DATE: 5-30-18

APPLIES TO: This service bulletin applies to certain model year 2016 through 2019, K2 and K3 model motorhome chassis built between 12/19/2014 and 2/20/2018.

CONDITION: Minimal clearance between the tag axle tire and diesel exhaust fill support bracket.

CORRECTION: Rework the DEF fill bracket to gain adequate clearance.

FIG. 2-1

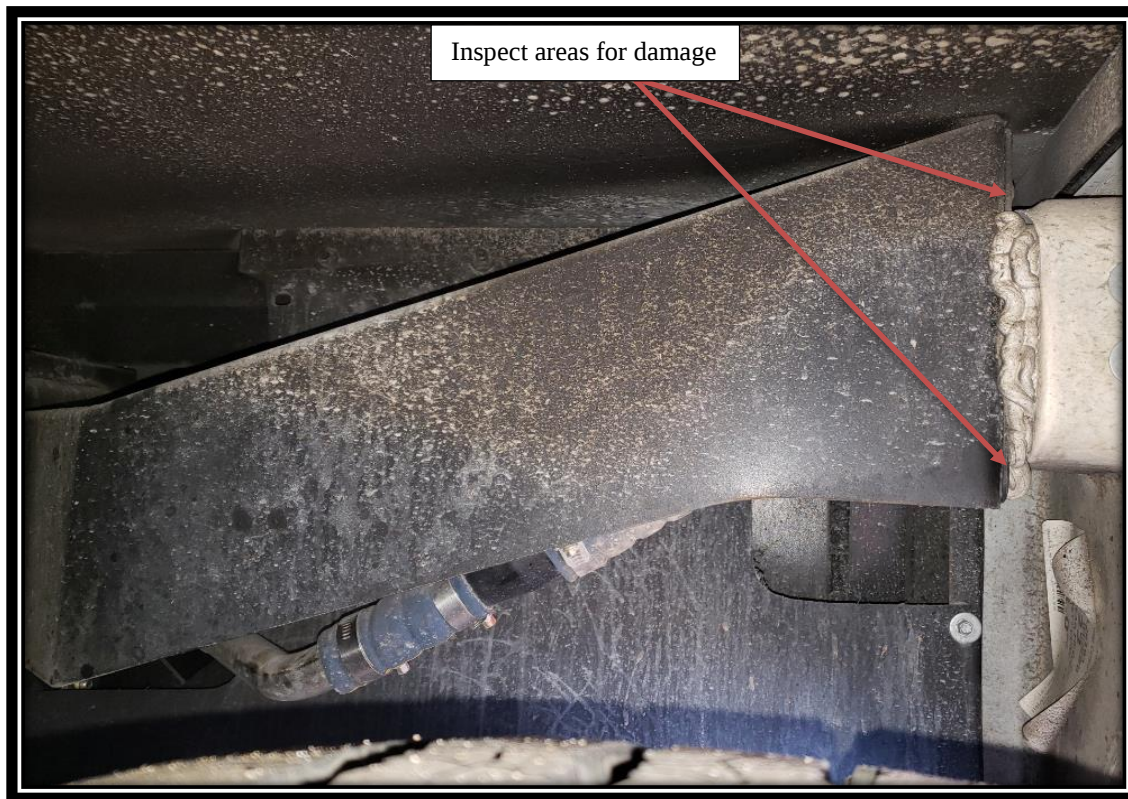
5. Locate DEF fill support mounted in rear of tag axle wheel well and inspect for damage. Refer to FIG. 2-1.
 - a. Pay special attention to bracket and body interface at location of plastic DEF fill.
 - b. If damage has occurred to plastic DEF fill it should be replaced.
 - c. If DEF fill is damaged contact Customer Service (P/N 908-1272-01 {PIA in 2772-LL2-001} is not part of the service kit)

FIG. 3-1

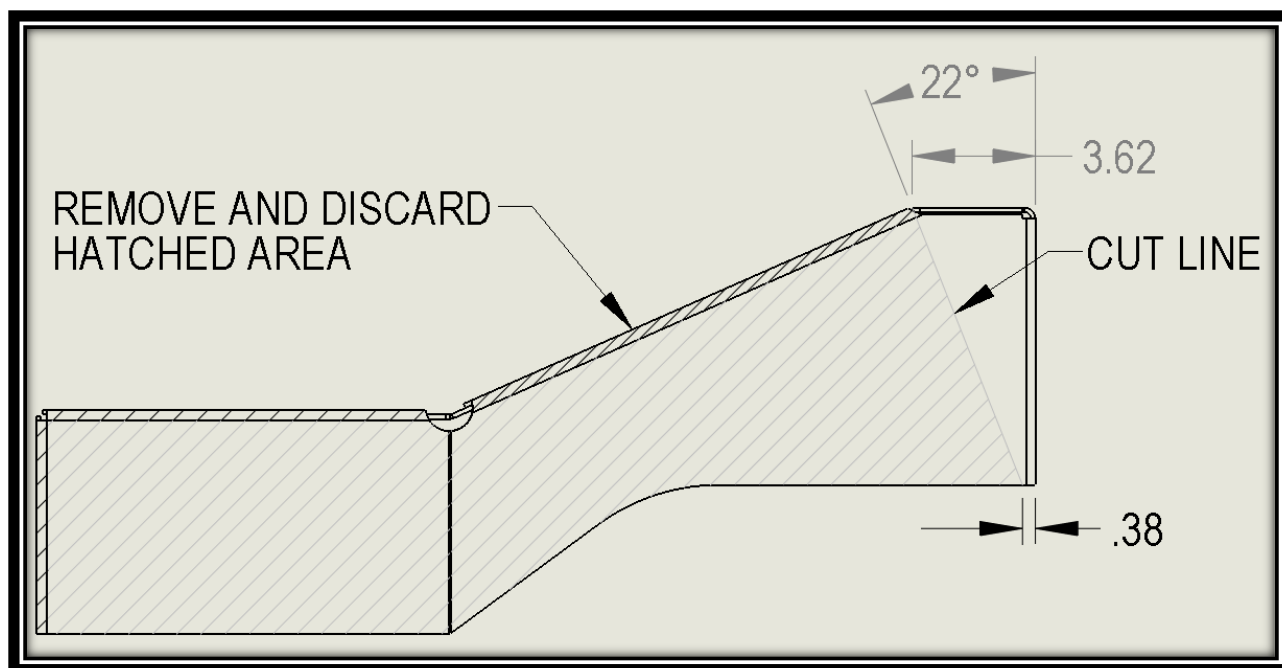
6. Using dimensions provided, layout cut pattern. Refer to FIG 3-1.
7. Carefully cut bracket, cut-off wheel or Sawzall preferred. **Use caution not to damage the DEF fill and hose.**

FIG. 4-1

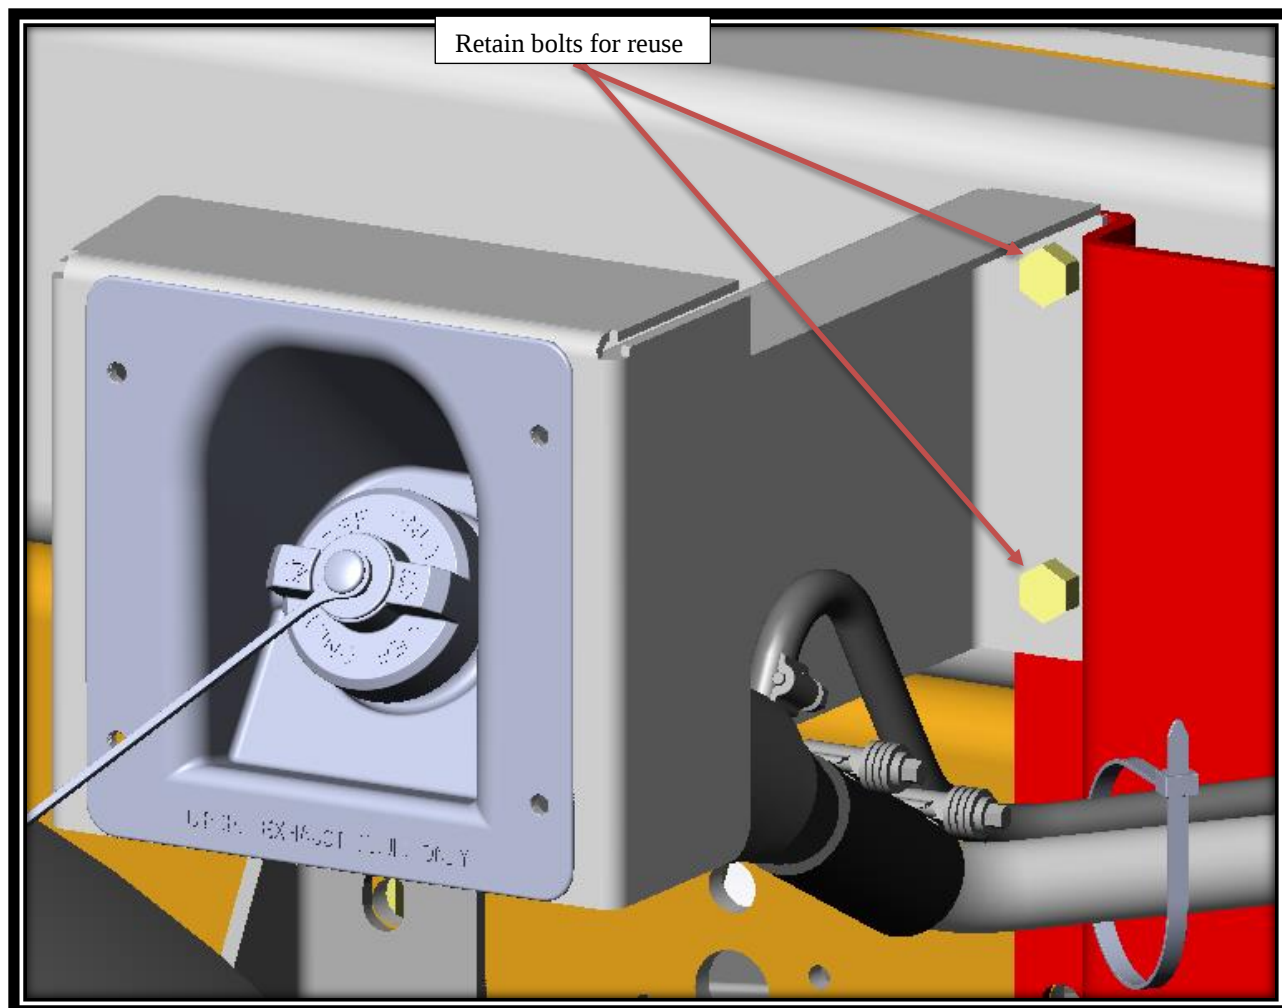
8. Unbolt bracket from frame by removing two ½" bolts. Retain for reuse. Refer to FIG. 4-1.

FIG. 5-1

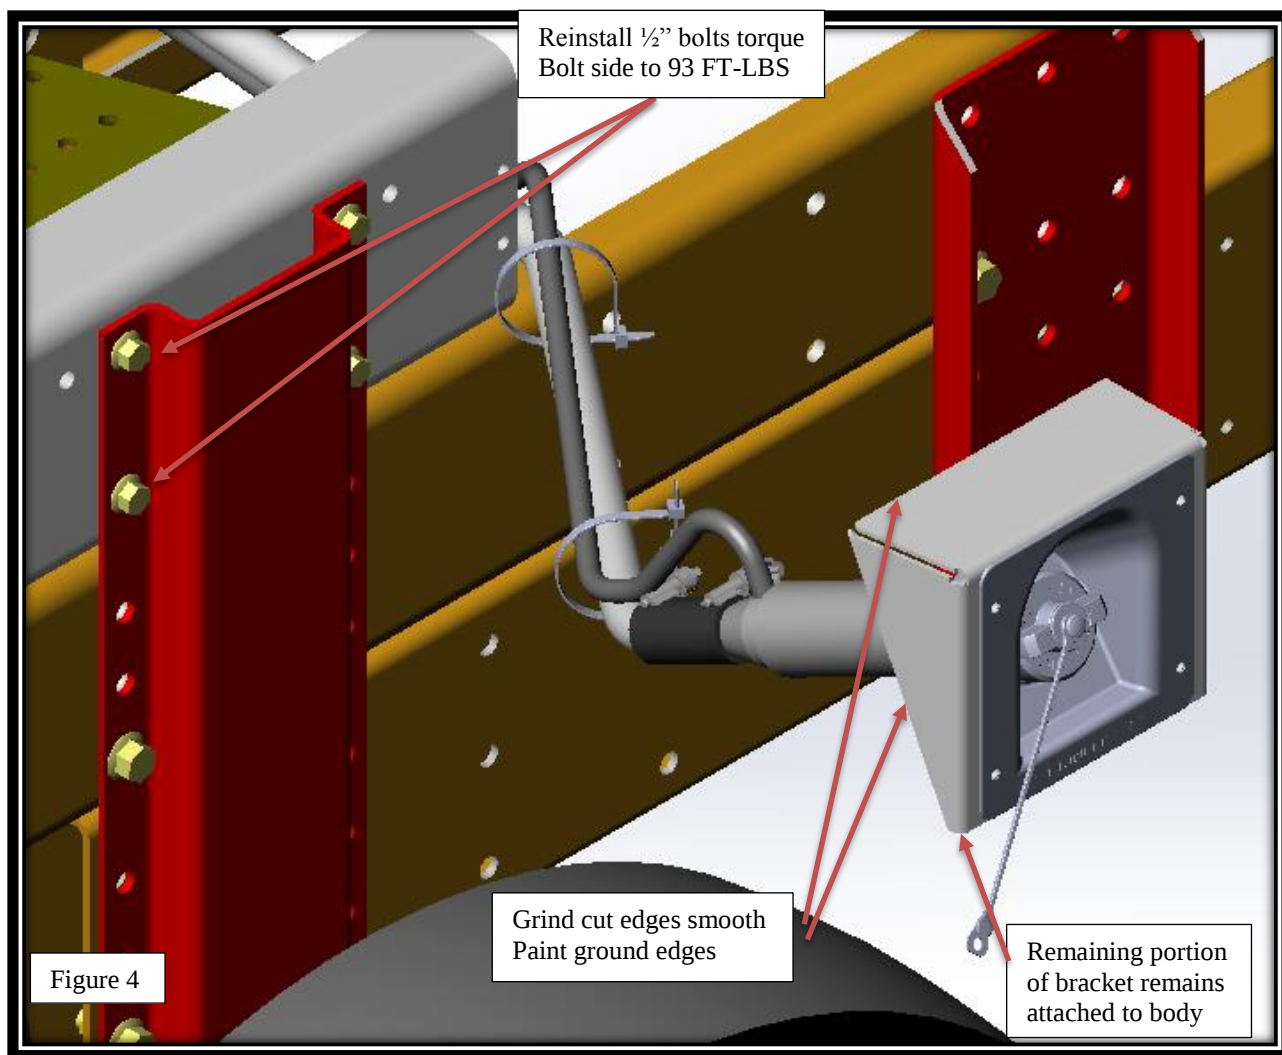
9. Remove and discard cutoff part of bracket. Refer to FIG. 5-1.
10. Reinstall retained hardware - $\frac{1}{2}$ " bolts and torque bolt side to 93 FT-LBS. Refer to FIG. 5-1.
11. Grind cut edges of bracket remaining on coach, smooth. Refer to FIG. 5-1.
